MONTGOMERY COUNTY HISTORIC PRESERVATION COMMISSION
STAFF REPORT

| Address: | 7406 Maple Avenue, Takoma Park | Meeting Date: | 8/14/2024 |
| Proposal: | Partial demolition, fenestration alteration, construction of new rear addition, hardscape alterations. | | |

STAFF RECOMMENDATION

LEFT SIDE ELEVATION (WEST)

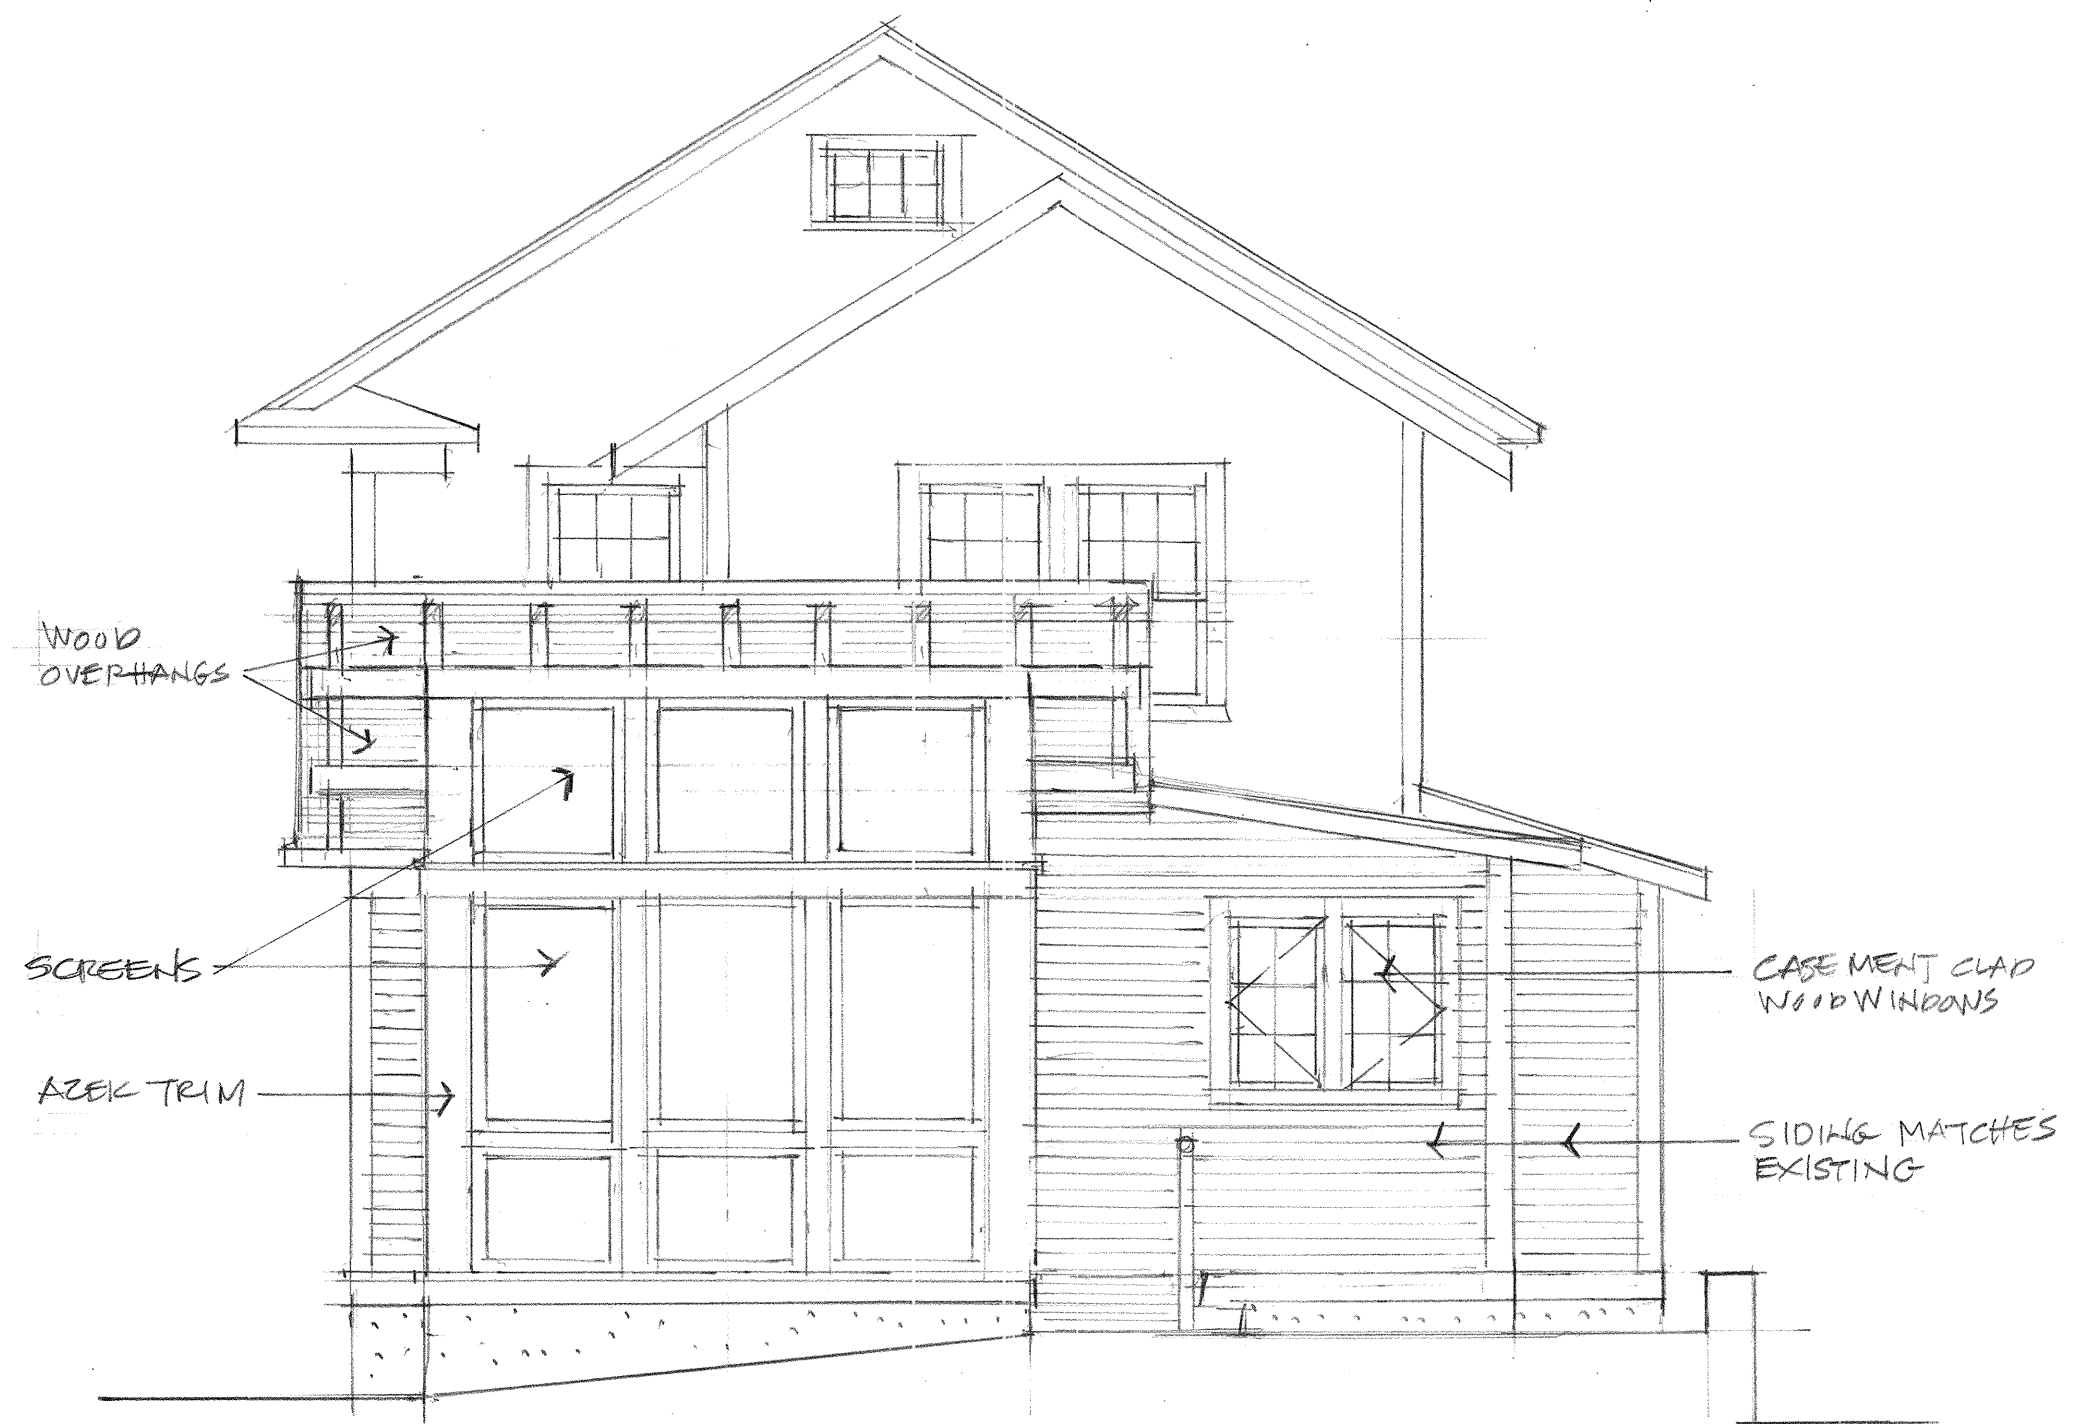
On the left elevation, the applicant proposes to remove a non-historic one six-over-one wood sash window in the historic house and one six-over-one wood sash window in the non-historic addition. The window opening in the historic portion of the house is installed in a non-historic bump out. This window

opening will be enlarged and an aluminum-clad wood Chicago window will be installed in the opening. In the non-historic addition, the applicant proposes to install a three-window aluminum-clad wood casement assembly with a higher sill. The siding surrounding both window openings will be repaired to match the historic clapboards. Staff finds these two windows are so far to the rear of the right elevation, that their removal and replacement will not have a substantial impact on the character of the house or surrounding district. Additionally, Staff finds replacing the window in the non-historic addition will not be visible from the right-of-way nor will it impact historic fabric. As with the windows on the right elevation, Staff finds the proposed replacement window is appropriate in design and materials.

Staff finds the proposed window and siding changes are appropriate under the *Design Guidelines*, 24A-8(b)(2) and (d); and Standards 2, 9, and 10

PROPOSED
 REAR ELEVATION (North)

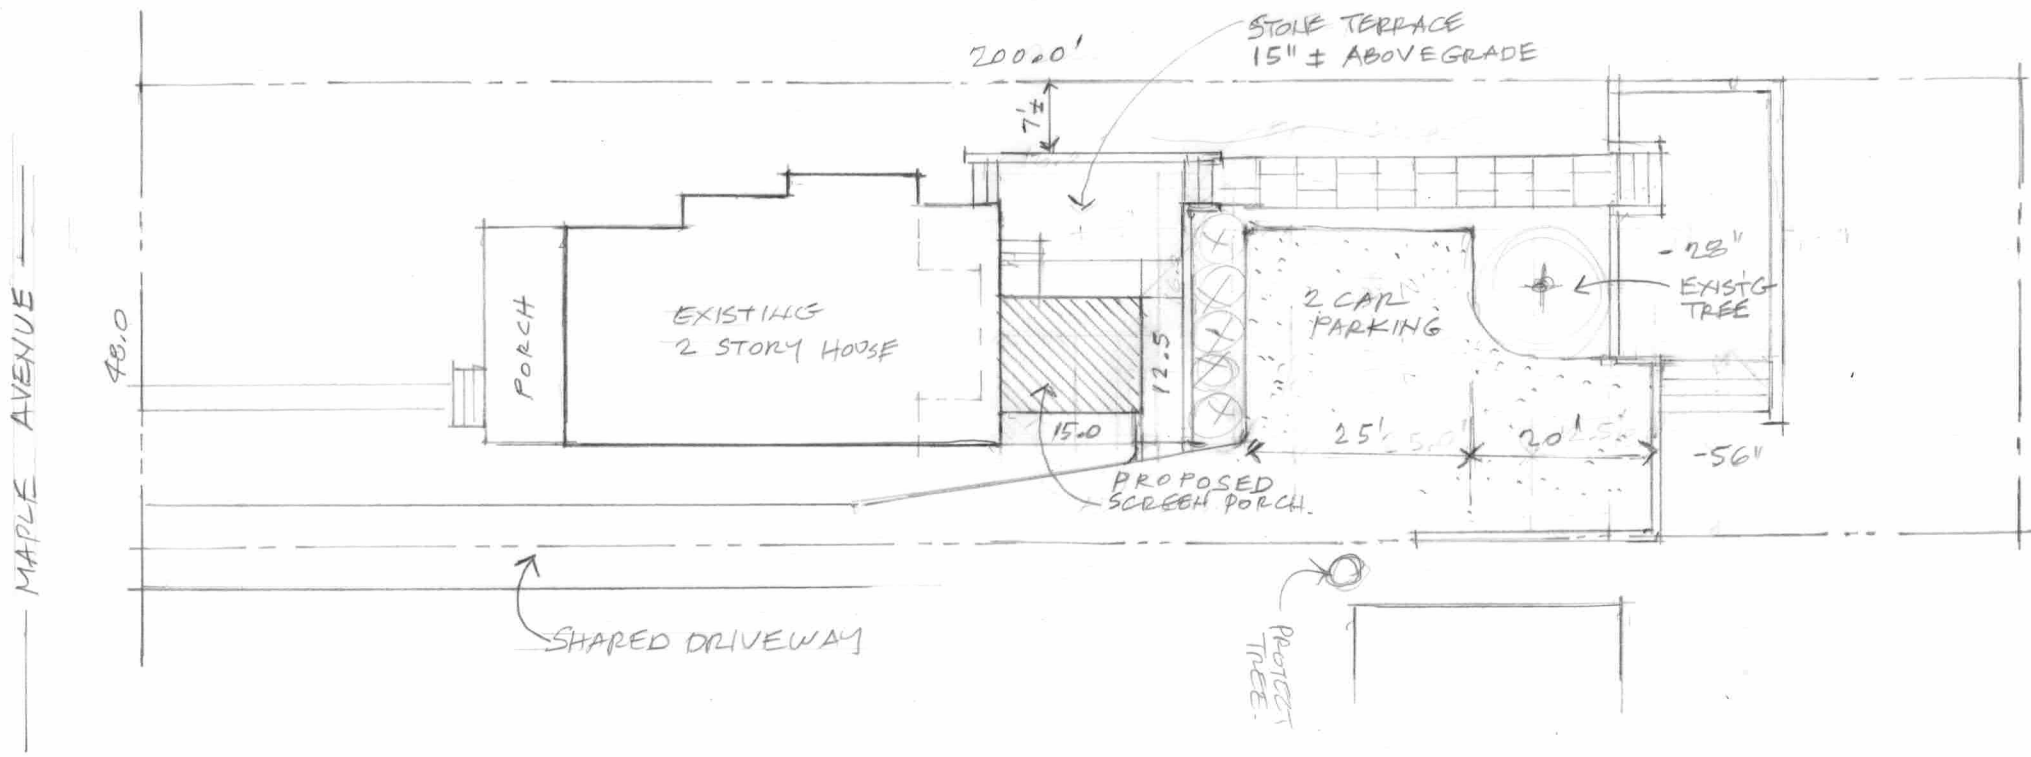
On the rear elevation, the applicant proposes to remove one window opening on the first floor and convert it to a door to access the screened-in porch (discussed below); and enlarge the other first-floor window opening to install a pair of six-light aluminum-clad casement windows. As with the other elevations, the applicant proposes to repair the siding to match the appearance of the historic clapboard siding. Because these changes are proposed for a non-historic portion of the house that is not at all visible from the public right-of-way, Staff finds the proposed changes will not have a significant impact on the character of the resource or surrounding district. Staff additionally finds the proposed window is appropriate for the character of the house and surrounding district and recommends the HPC approve the rear window alterations.

To the rear of the non-historic addition, the applicant proposes to construct a screened-in porch. The porch, which will be inset from the right-side wall plane by 1' 6" (one foot, six inches) and 10' (ten feet) on the left elevation, measures approximately 15' × 12' 6" (fifteen feet deep by twelve feet, six inches wide). The applicant suggests the porch will only be minimally visible from Maple Ave. The porch will be framed in wood, with Azek trim, and topped with a single 3:12 shed roof slope.

Figure 3: Proposed rear elevation.

Based on the majority of the HPC’s findings at the Preliminary Consultation, Staff recommends the HPC approve the proposed screened-in porch under the *Design Guidelines*; 24A-8(d); and Standards 9 and 10.
